State of New Mexico
 Energy, Minerals and Natural Resources

Form C-103
 Revised July 18, 2013

WELL API NO. 30-025-53624
5. Indicate Type of Lease STATE <input checked="" type="checkbox"/> FEE <input type="checkbox"/>
6. State Oil & Gas Lease No.
7. Lease Name or Unit Agreement Name Lea Unit
8. Well Number 203H
9. OGRID Number 330396
10. Pool name or Wildcat [37570] LEA; BONE SPRING
4. Well Location Unit Letter <u>I</u> : <u>2483</u> feet from the <u>S</u> line and <u>1300</u> feet from the <u>E</u> line Section <u>14</u> Township <u>20S</u> Range <u>34E</u> NMPM County <u>Lea</u>
11. Elevation (Show whether DR, RKB, RT, GR, etc.) 3653 GL

Avant Operating, LLC requests the following changes to the Lea Unit 14 11 203H well.

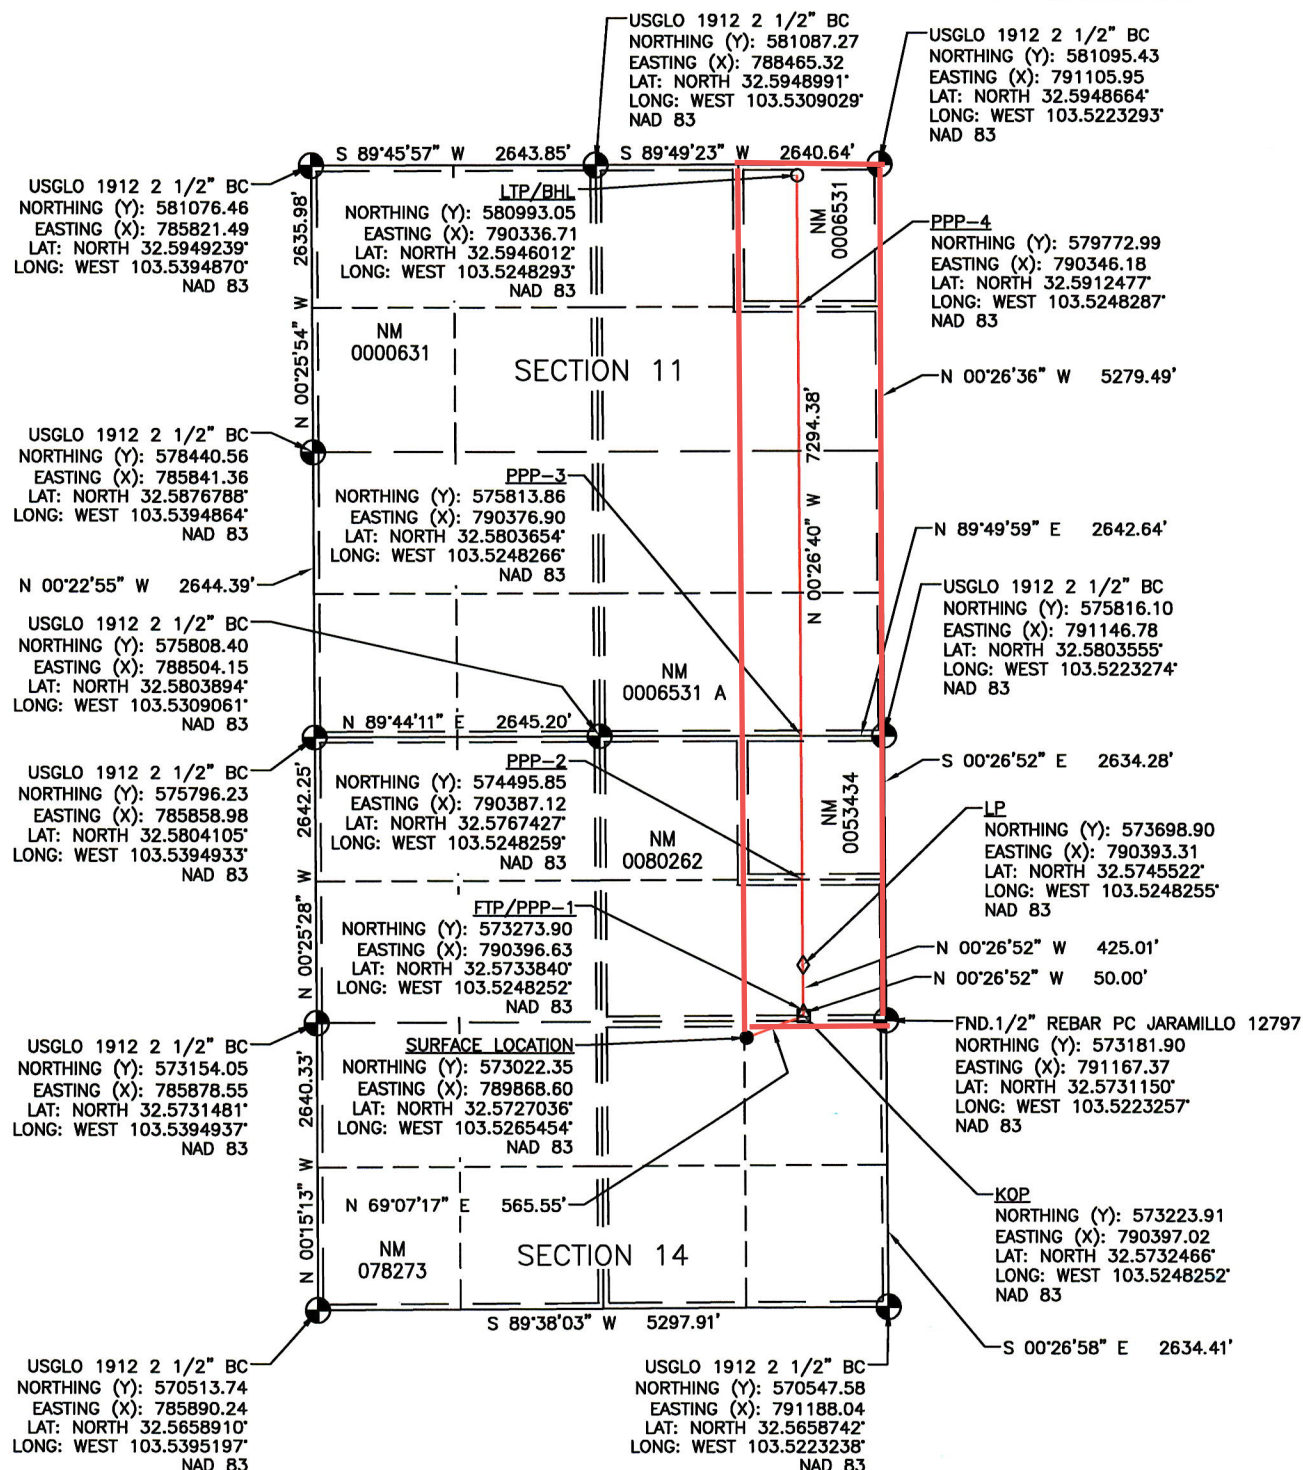
1. Name change from the "Lea Unit 14 11 203H" to "Lea Unit 203H" to comply with unit naming convention, see attached updated plat.
2. BHL change from 100' FNL & 990' FEL to 100' FNL & 770' FEL, please see attached revised C-102 plat and directional plans to reflect this change.
3. Perform offline cement procedure on surface & intermediate sections & run possible DV Tool in intermediate casing, see attached BLM approval.

UL	Section	Township	Range	Lot	Ft. from N/S	Ft. from E/W	Latitude	Longitude	County
A	II	20 S	34 E		100 FNL	770 FEL	32.5946012° N	103.5248293° W	LEA

FOOTAGES		
SHL	2483' FSL	1300' FEL
KOP	2590' FNL	770' FEL
FTP/PPP-1	2540' FNL	770' FEL
LP	2115' FNL	770' FEL
PPP-2	1318' FNL	770' FEL
PPP-3	0' FNL	770' FEL
PPP-4	1320' FNL	770' FEL
LTP/BHL	100' FNL	770' FEL
